Long Branch Sector Plan, Worksession 6

Long Branch Sector Plan, Worksession 2

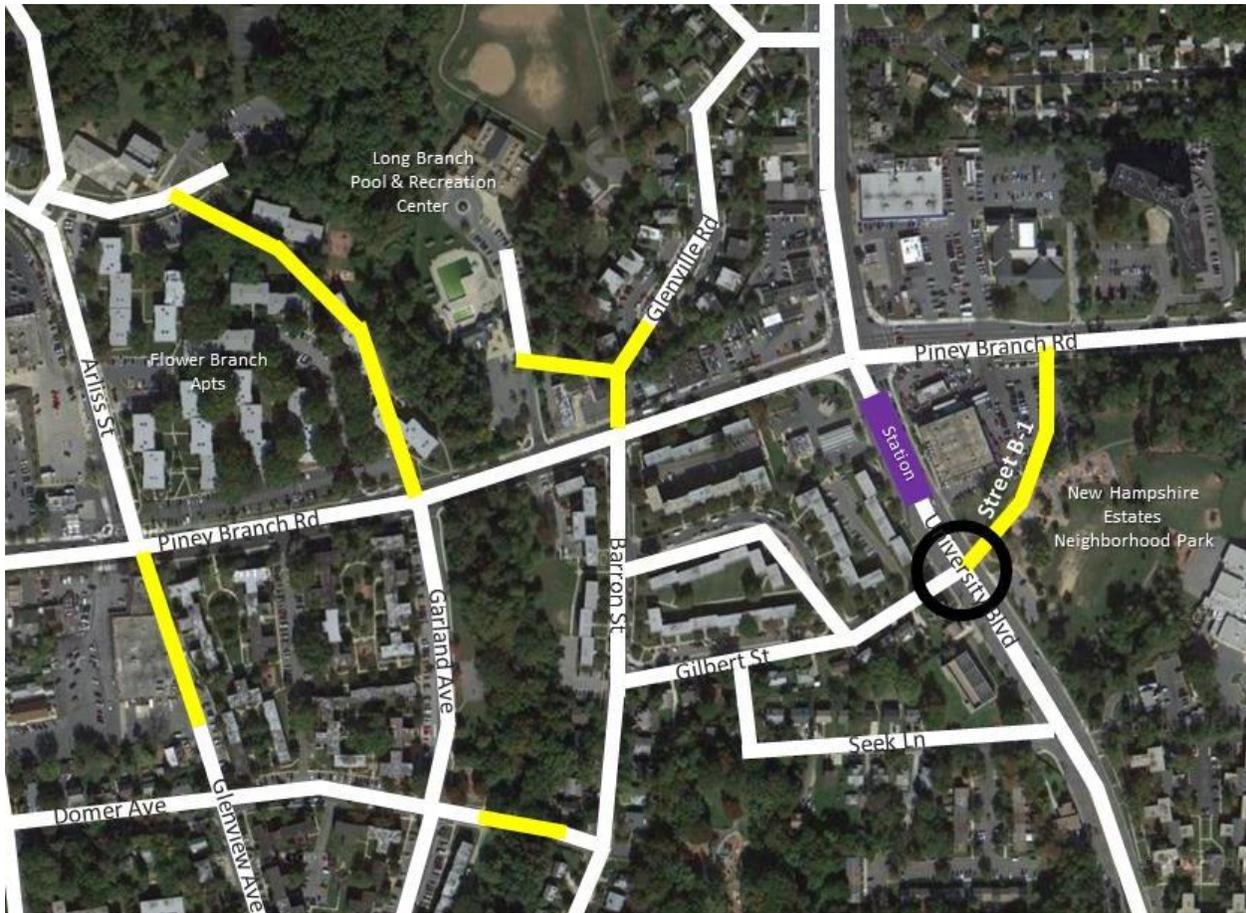
This is an addendum to "Issue 9: Additional Right-of-Way for the Purple Line" on page 23 and 24 of the March 21st staff report.

The following note should be added in Table 2, on page 51 of the Sector Plan, to the Piney Branch Rd. and Arliss Street right-of-way recommendations:

"Additional right-of-way requirements for the Purple Line will be determined either at the time of final design for the Purple Line or at the time of subdivision, using latest project-level plans available for the Purple Line."

Exhibit 1: MTA's Proposed Access to Long Branch Recreation Center and Pool (From Eastbound Direction)

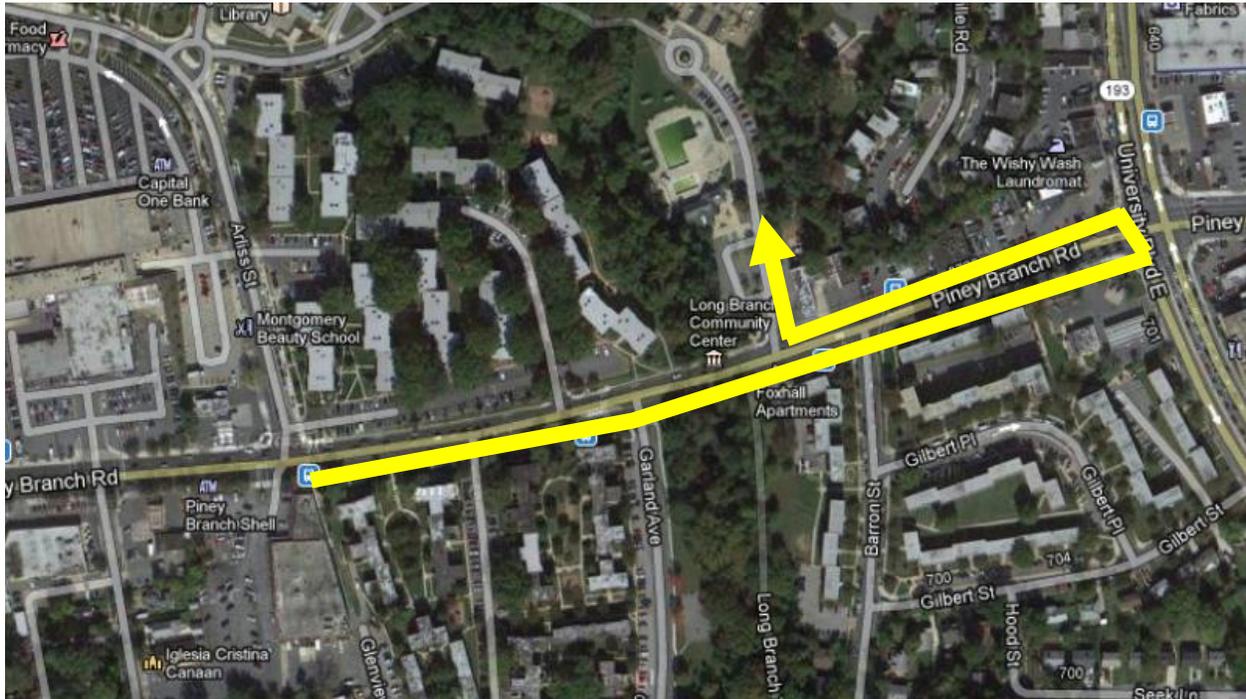
Because the Purple Line is proposed to operate in the median of Piney Branch Road, left turns from Piney Branch Road would be prohibited into Garland Avenue and Barron Street, as well as into and out of all driveways along Piney Branch Road between University Blvd. and Arliss Street. Vehicles intending to make these left turns would be required to travel beyond the intersection, make a U-turn at the next available intersection, and make a right turn onto the desired street or driveway. This is particularly problematic for the Long Branch Pool and Recreation Center.

MTA states that facility patrons will still be able to access the facilities via U-turns at Arliss Street and University. Vehicles traveling in the eastbound direction on Piney Branch Road would have to pass the recreation center, make a U-turn at University Blvd., and then turn right into the recreation center (see Exhibit 1).

Exhibit 2: MTA's Proposed Egress from Long Branch Recreation Center and Pool (To Eastbound Direction)

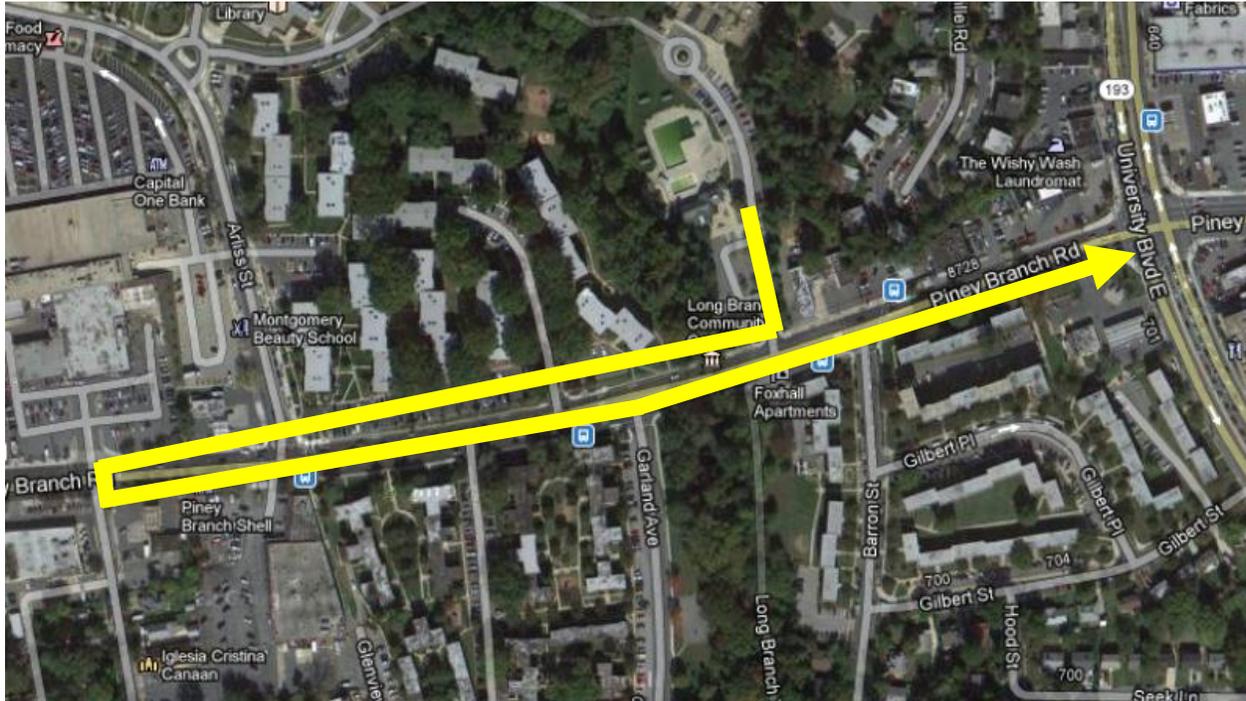
Exiting vehicles headed in the eastbound direction would have to make a right onto Piney Branch Road, make a U-turn at Greenwood Avenue, and then head in the eastbound direction on Piney Branch Road (see Exhibit 2). Of the two access restrictions, the proposed replacement of the entering left turn with a U-turn at University Blvd. is the most concerning.

Exhibit 3: Fourth Access Option to Long Branch Pool and Recreation Center

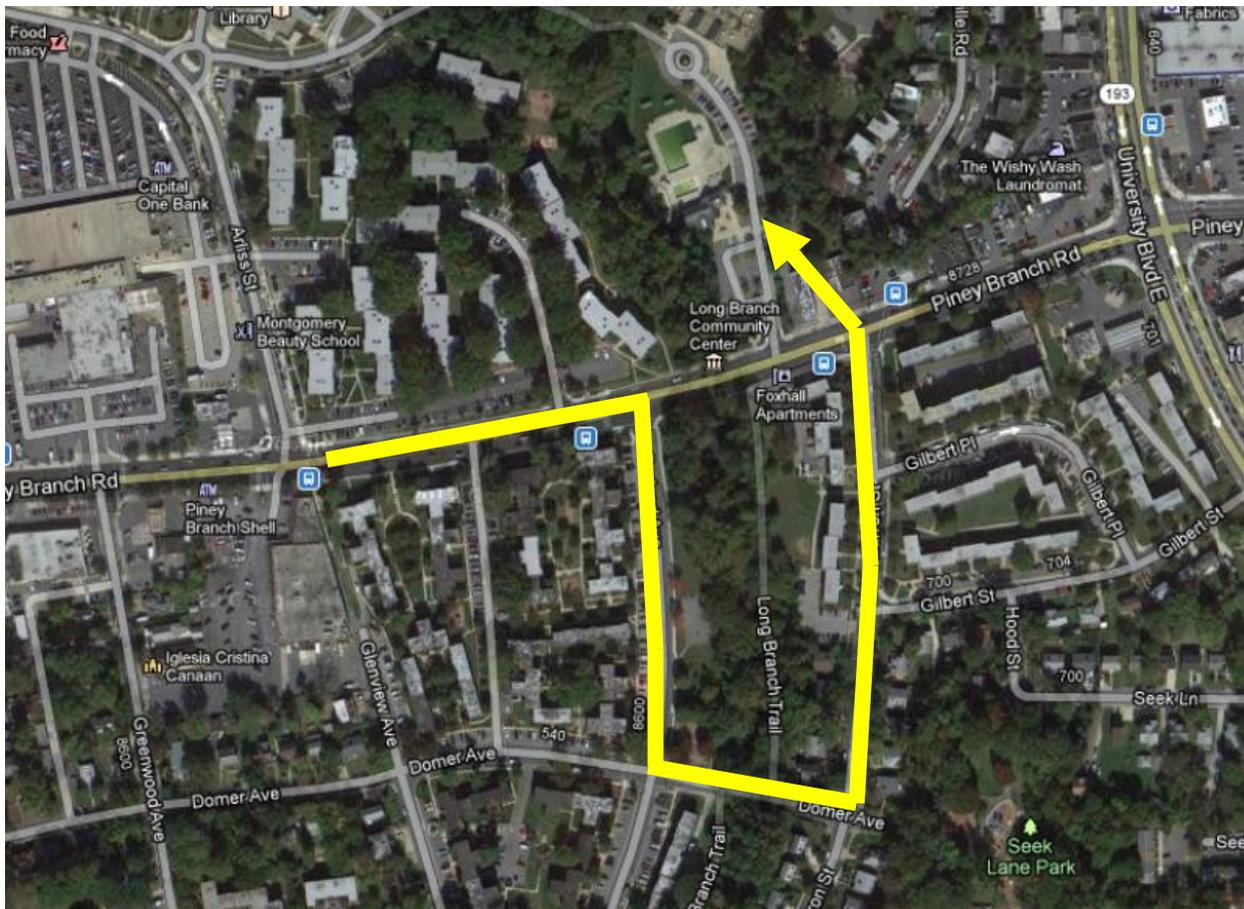
In the February 28th briefing, Planning Department staff presented a fourth option – Option 1A – that would realign the driveway with Barron Street, but instead of adding a new left turn lane for eastbound traffic would instead route visitors through south on Garland Avenue, across the proposed Domer Avenue multimodal bridge³, and north on Barron Street (see Exhibit 3). M-NCPPC staff believes this option provides the best value to the County because the two components of the access solution have independent utility:
